CD-2020-157

Re: Radioactive Material License UT 2300478 -
Groundwater Quality Discharge Permit UGW450005; **Amendment and Modification
Request to Reduce Capacity and Disposal Footprint**

**STATE OF UTAH 11e.(2) BYPRODUCT
RADIOACTIVE MATERIAL LICENSE
AMENDMENT REQUEST (UT2300478)**

Appendix M
Revised Engineering Drawing Set

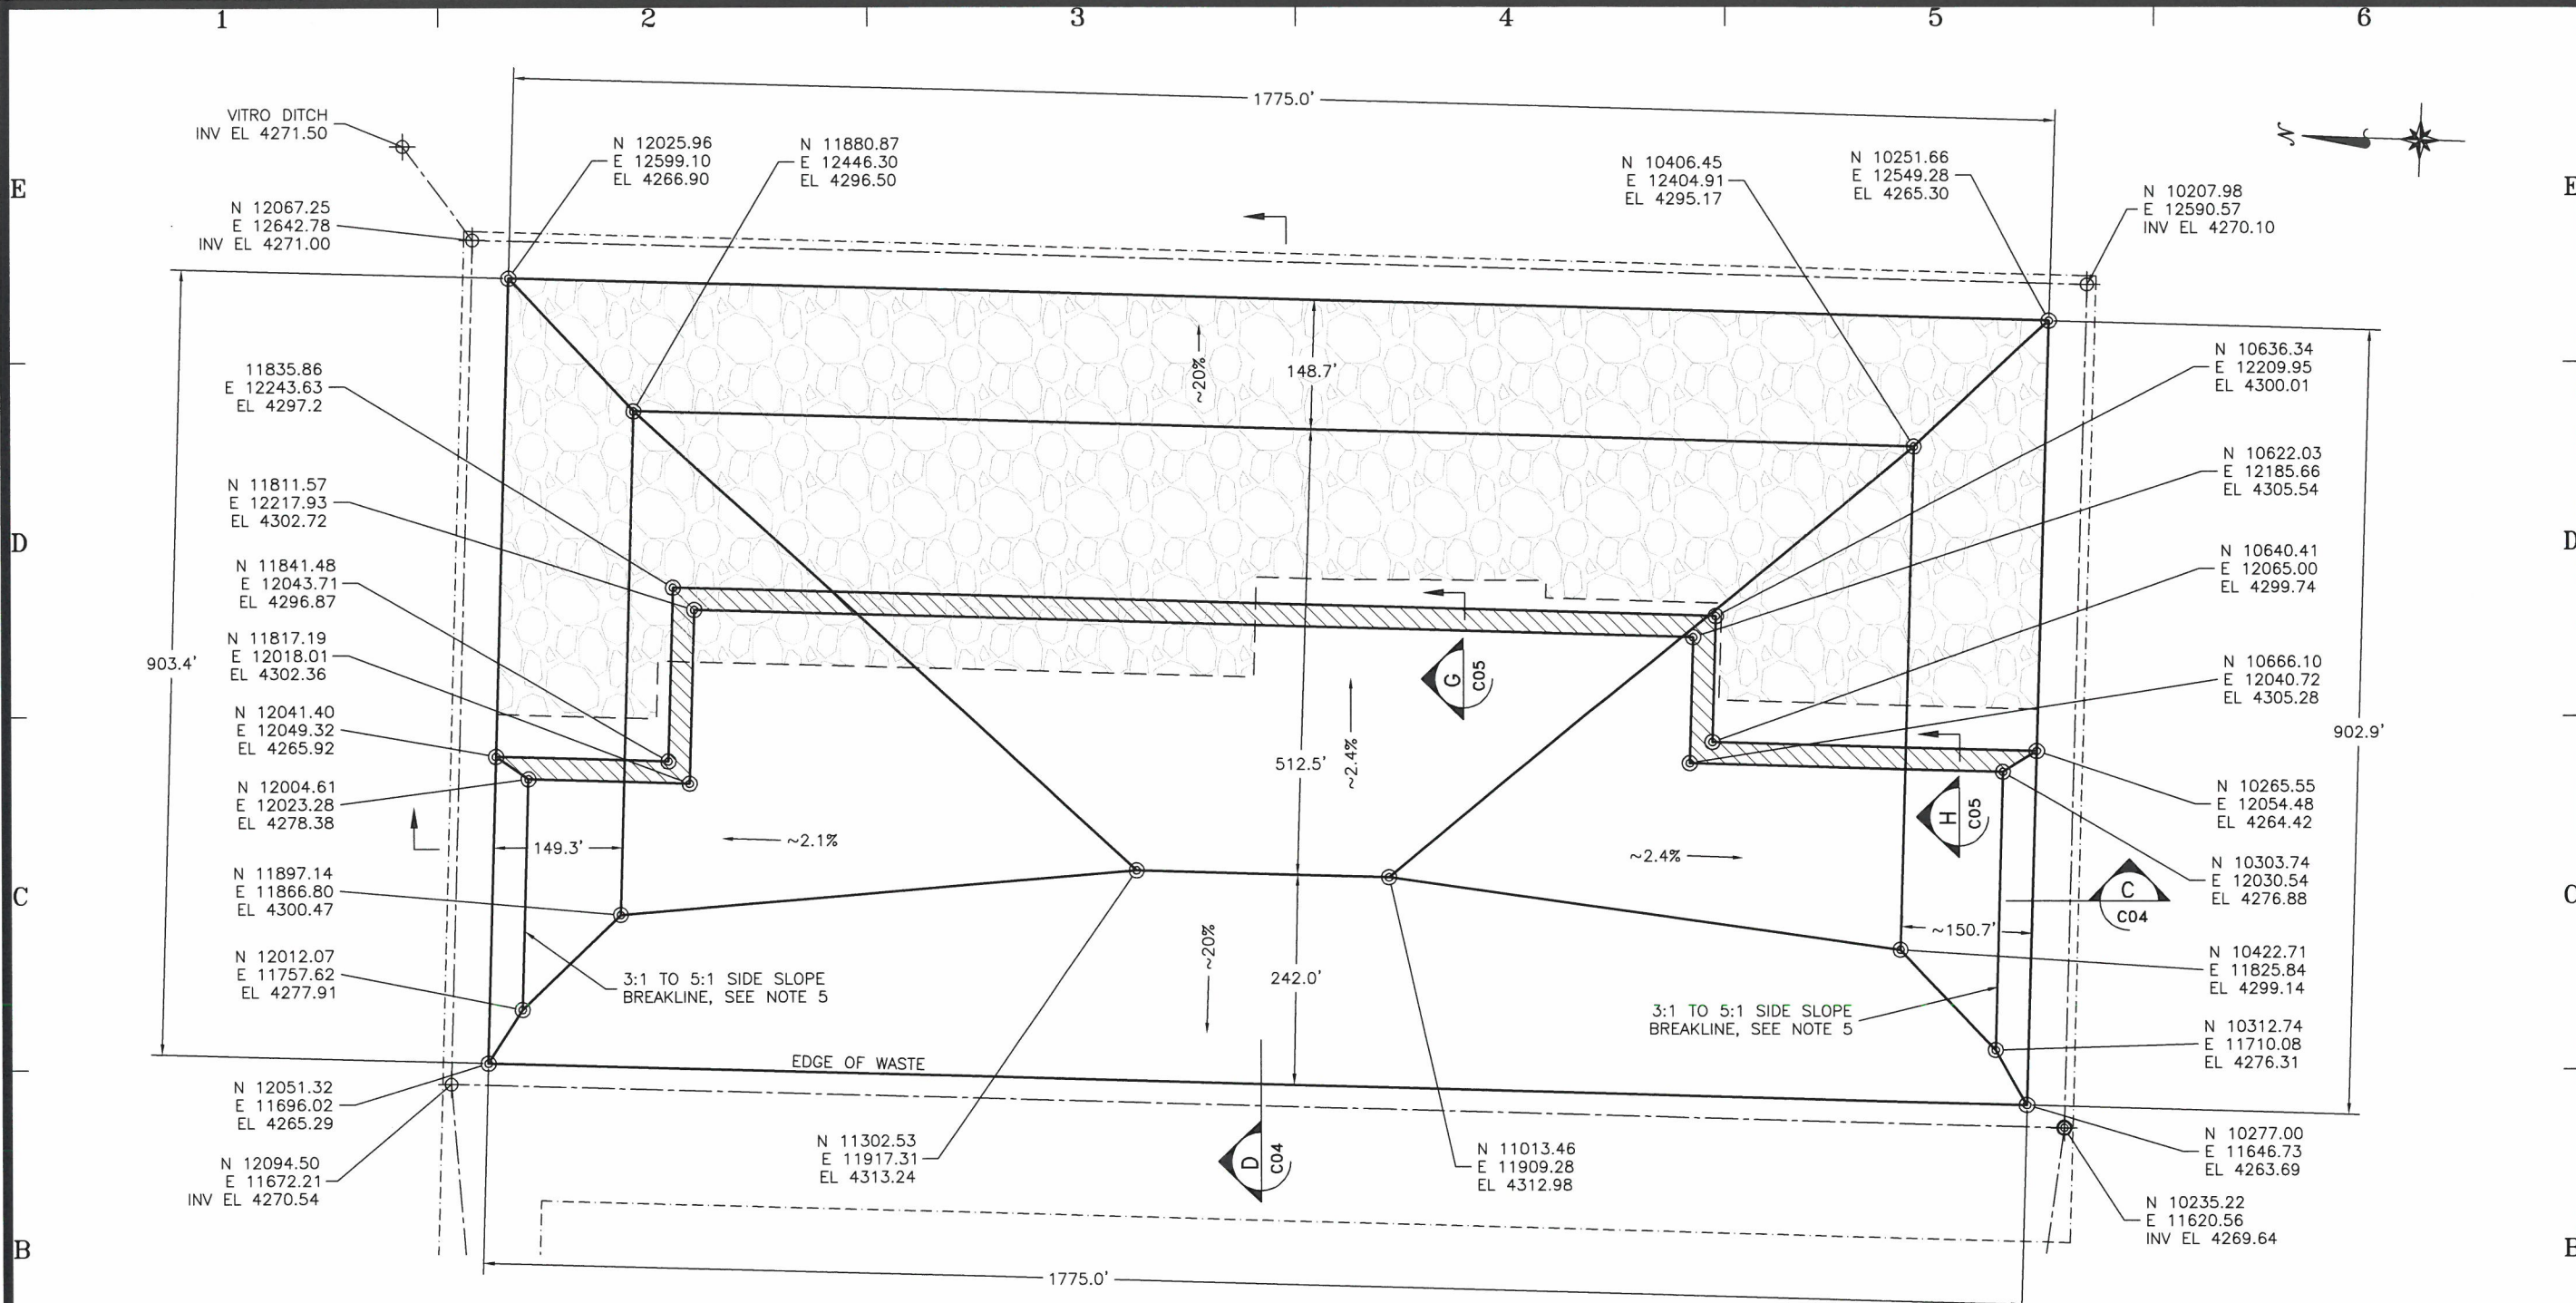
During active operations, the 11e.(2) Embankment is surrounded by run-on and run-off berms. Run-on berms prevent stormwater run-on, from ambient precipitation in the vicinity of the facility, into the emplaced waste before final cover is built. Run-on berm design criteria is not impacted by a reduction in 11e.(2) Embankment capacity. The disposal area is surrounded by a perimeter berm that is at least 3 feet above the natural ground. This run-on control berm is designed to protect the disposal operations against the Probable Maximum Flood. The design calculations for the site perimeter berms are located in Appendix E of EnergySolutions, (2013). Calculations for the Probable Maximum Precipitation and Probable Maximum Flood are also located in Appendix G of EnergySolutions, (2013). The final drainage design is shown on Engineering Drawing 20001-C03.

The drainage area contained by the 11e.(2) embankment perimeter drainage ditch includes the landfill embankment, the ditch itself, and the perimeter inspection road surrounding the facility. Engineering Drawing 20001-C03 provides centerline drainage ditch locations and elevations around the 11e.(2) landfill embankment. From Engineering Drawing 20001-C03, the following ditch centerline distances may be estimated:

From the ditch lengths and centerline elevations in Drawing 20001-C03, the following ditch slopes are determined:

North Side = 971 feet in length with an elevation change of 0.46 feet; this yields a slope of $(0.46 \text{ ft} / 971 \text{ ft}) = 4.74 \times 10^{-4} \text{ ft/ft}$

South Side = 970 feet in length with an elevation change of 0.46 feet; this yields a slope of $(0.46 \text{ ft} / 970 \text{ ft}) = 4.74 \times 10^{-4} \text{ ft/ft}$

East Side = 1,859 feet in length with an elevation change of 0.9 feet; this yields a slope of $(0.9 \text{ ft} / 1,859 \text{ ft}) = 4.84 \times 10^{-4} \text{ ft/ft}$

West Side = 1,859 feet in length with an elevation change of 0.9 feet; this yields a slope of $(0.9 \text{ ft} / 1,859 \text{ ft}) = 4.84 \times 10^{-4} \text{ ft/ft}$

DITCH CROSS SECTION
 E C04 10 0 10 20

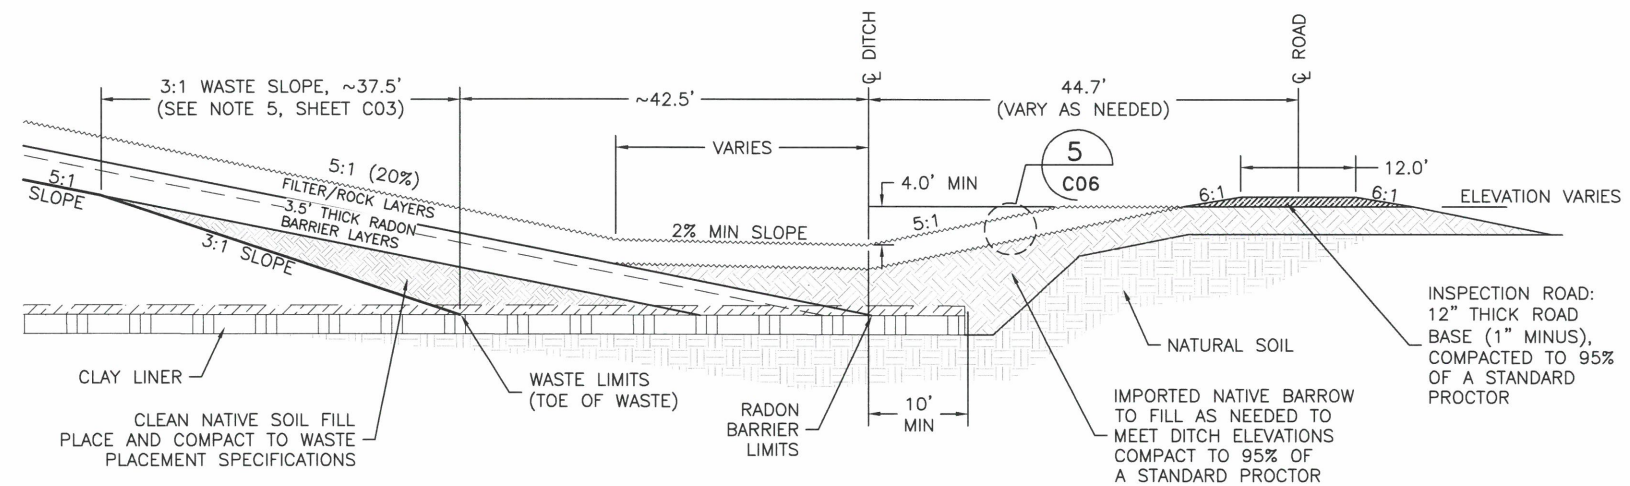
Safety factors have been calculated for critical design case of the downstream ditch system. Consideration of the ditch system provides a maximum projected drainage runoff. For the normal condition, the safety factor is calculated as the ratio of projected freeboard to the design criteria for freeboard. The calculated freeboard adjacent to the Embankment during the normal event is 2.71 feet and the design criteria freeboard (from Table 6-1) is 0.5 feet; therefore, the safety factor is $2.71 / 0.5 = 5.42$. For the abnormal event, the design criterion is that the ditch be able to contain the flow; no freeboard is necessary. The safety factor during the abnormal event in the drainage system is calculated as the ratio of design ditch depth to calculated flow depth: $4.00 / 2.71 = 2.96$.

The drainage ditch is constructed of compacted natural ground or borrow material covered with Type A filter rock and Type A riprap for erosion control. Drainage ditch slopes range from 0.000474 ft/ft and 0.000484 ft/ft (see Appendix L). Maximum interstitial water velocities in the ditches are calculated in Appendix L at 9.58×10^{-4} ft/sec. This velocity is the maximum possible velocity at the interface and is not dependent on the

DESIGNED BY	D. BOOTH
PROJECTED BY	T. ORTON
APPROVED BY	D. BOOTH
SCALE	AS SHOWN
DATE	09/23/20
DRAWING NO.	20001 U02

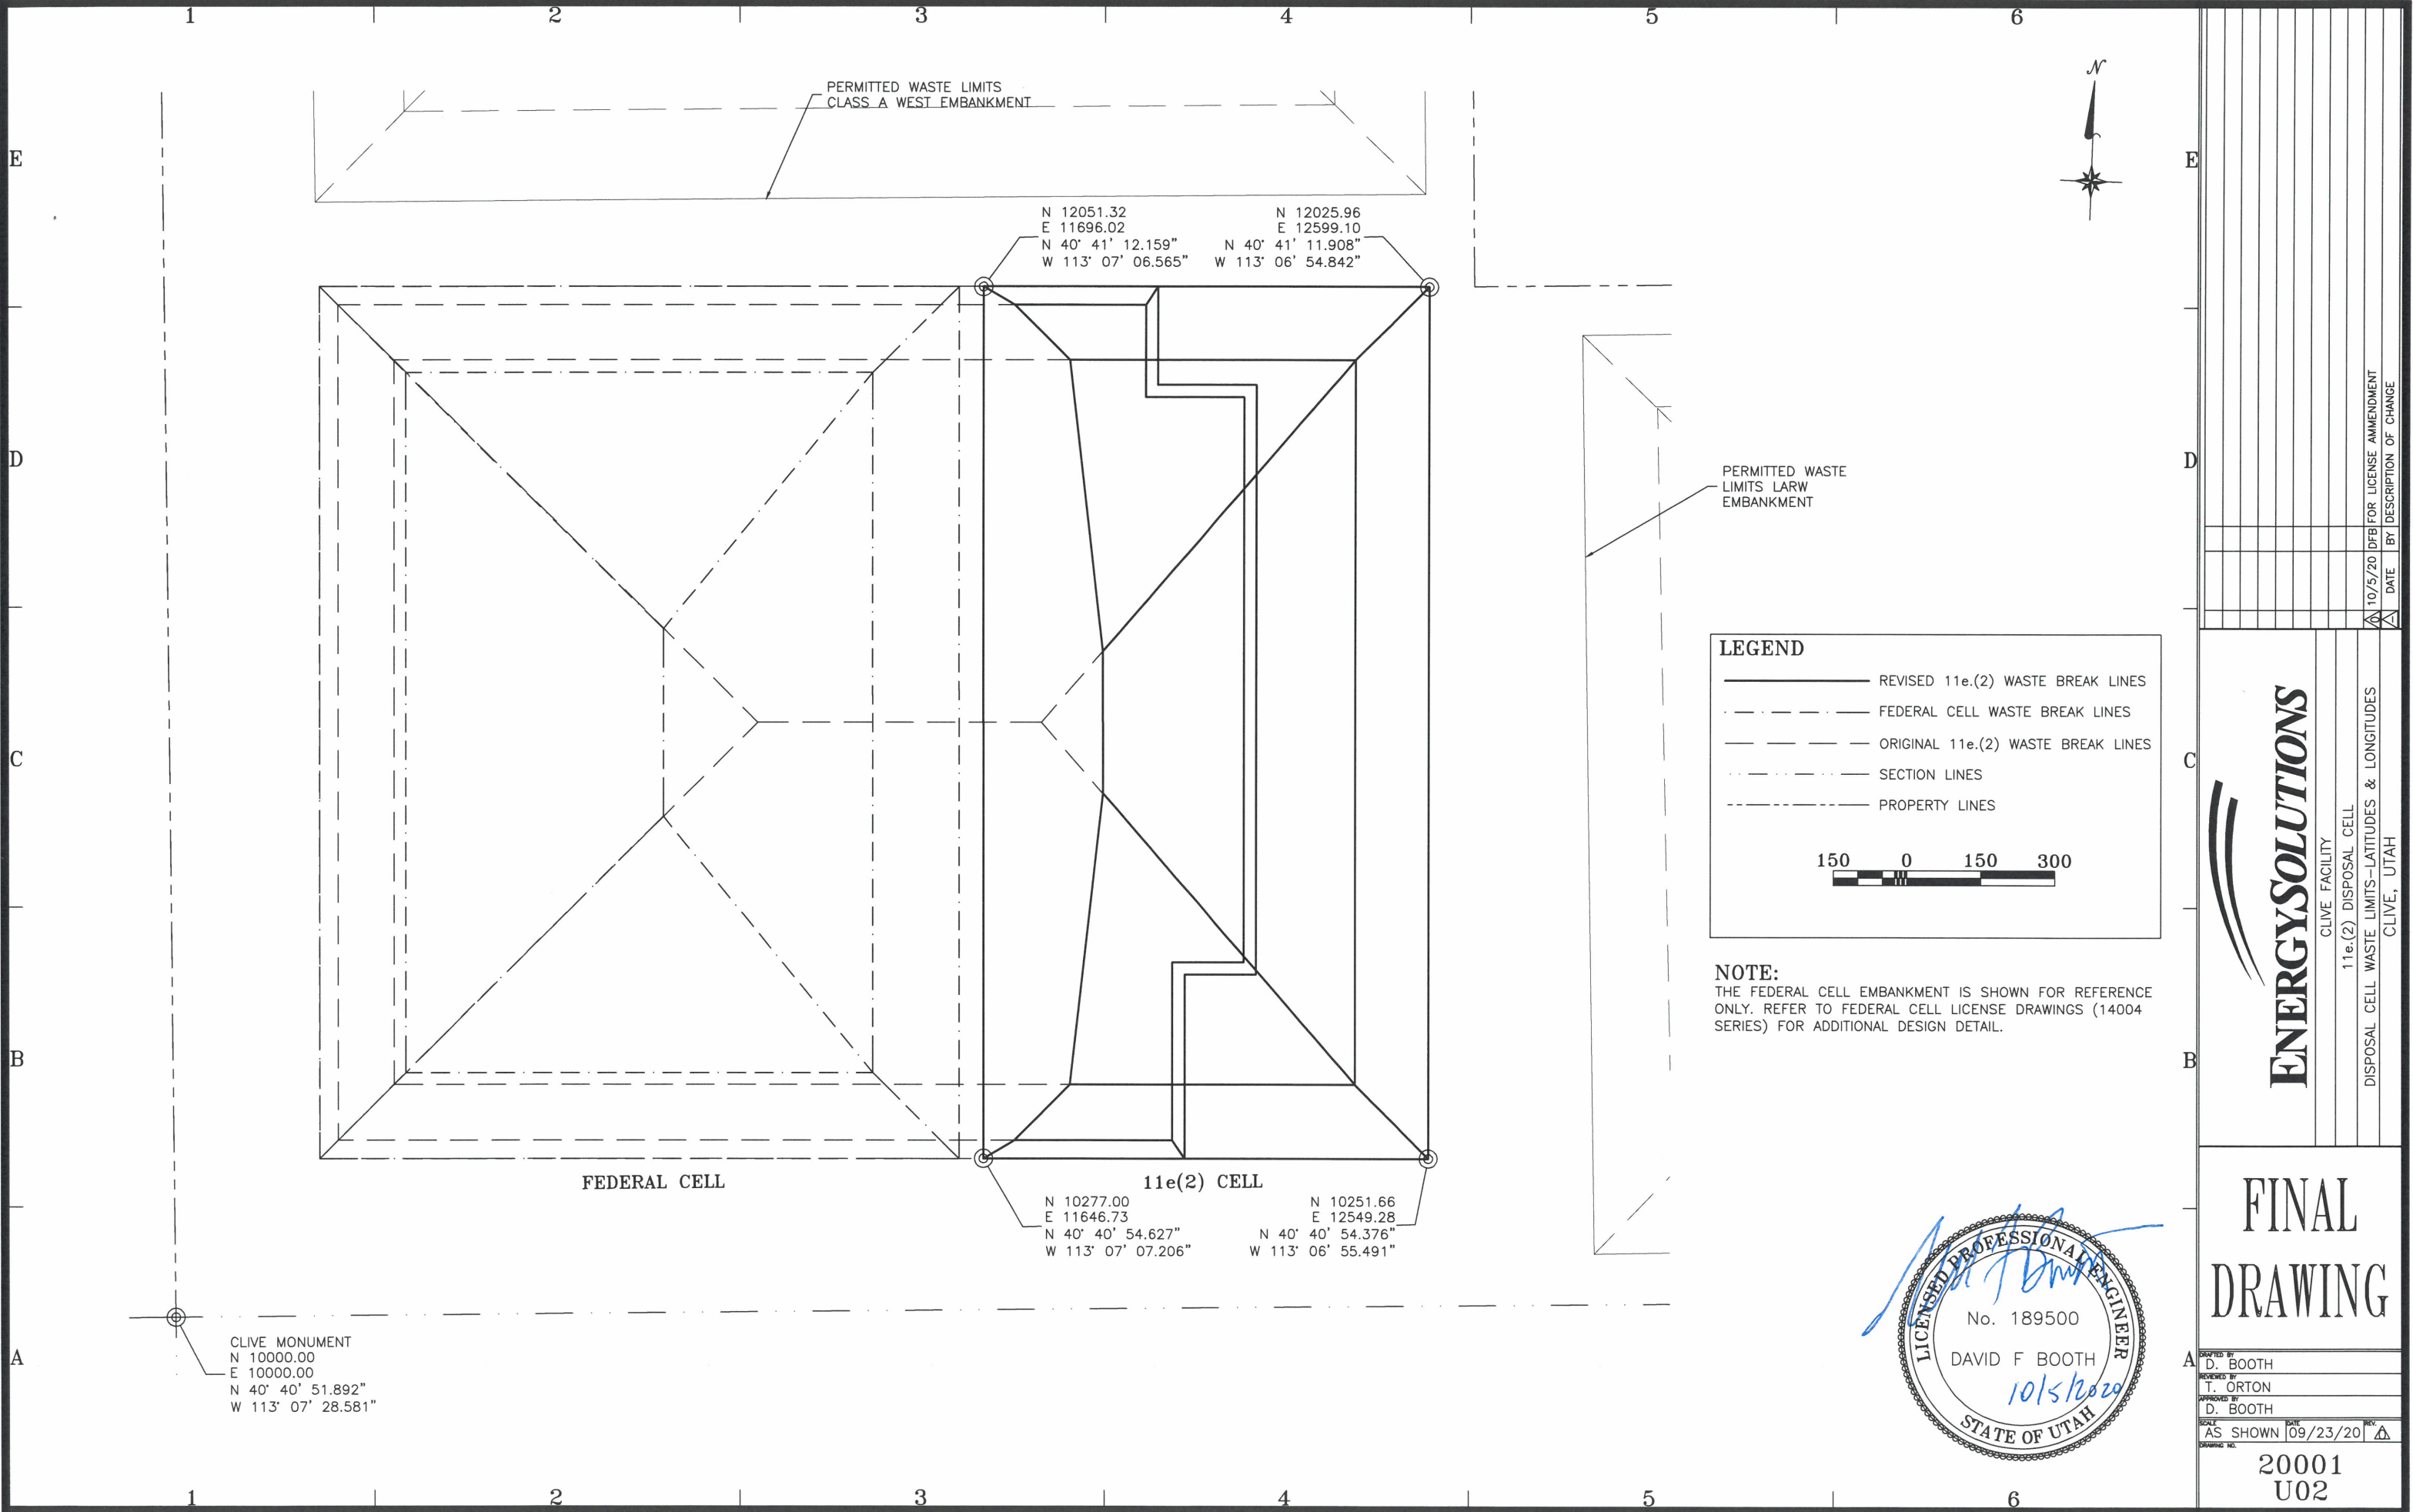
EnergySolutions also requests the Director modify Table 3 of Groundwater Quality Discharge Permit UGW450005 to reflect the following corner coordinates for the reduced disposal footprint.

- Northwest Corner
 - o Local Clive Coordinates - Northing 12,051.32, Easting 11,696.02
 - o Global Coordinates - Latitude(N) 40° 41' 12.159", Latitude(W) 113° 07' 06.565"

- Southwest Corner
 - o Local Clive Coordinates - Northing 10,277.00, Easting 11,646.73
 - o Global Coordinates - Latitude(N) 40° 40' 54.627", Latitude(W) 113° 07' 07.206"

- Southeast Corner
 - o Local Clive Coordinates - Northing 10,251.66, Easting 12,549.28
 - o Global Coordinates - Latitude(N) 40° 40' 54.845", Latitude(W) 113° 06' 55.564"

- Northeast Corner
 - o Local Clive Coordinates - Northing 12,025.96, Easting 12,599.10
 - o Global Coordinates - Latitude(N) 40° 41' 12.380", Latitude(W) 113° 06' 55.346"
